Docket Item #13
DEVELOPMENT SPECIAL USE PERMIT #2004-0001
THE PRESCOTT (Hopkins Warehouse)

Planning Commission Meeting
September 9, 2004

ISSUE: Consideration of a request for a development special use permit, with site plan and modifications, for construction of a residential condominium building with underground parking.

Figure 11 - Fayette Street Elevation

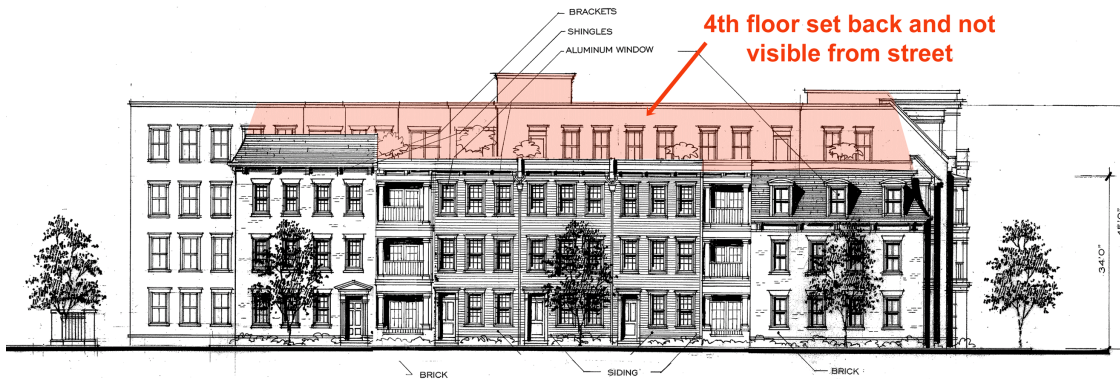
The Fayette Street elevation is the shortest (132.5 feet) facade and is intended to be smaller in scale in response to the buildings on the west side of Fayette Street and to be compatible with the generally smaller scale of the Parker-Gray District. In addition, the entire facade is set back from the sidewalk by approximately 15 feet to mimic the front yards of many houses of the District, such as the townhouses in the 400 block of North West Street. The Fayette Street facade is generally well resolved in mass, scale and architectural character.

Staff recommends the following changes to the Fayette Street elevation:

- Each of the doors as depicted on the preliminary elevations shall be operable.
- The top floor of the balconies-hyphens shall not include a roof.
- The three central townhouses shall consist of cementitious siding.
- That the roof and parapets be designed in a way to screen the roof-top deck.
- The three central clapboard townhouses shall be recessed 2' from the adjoining facades.
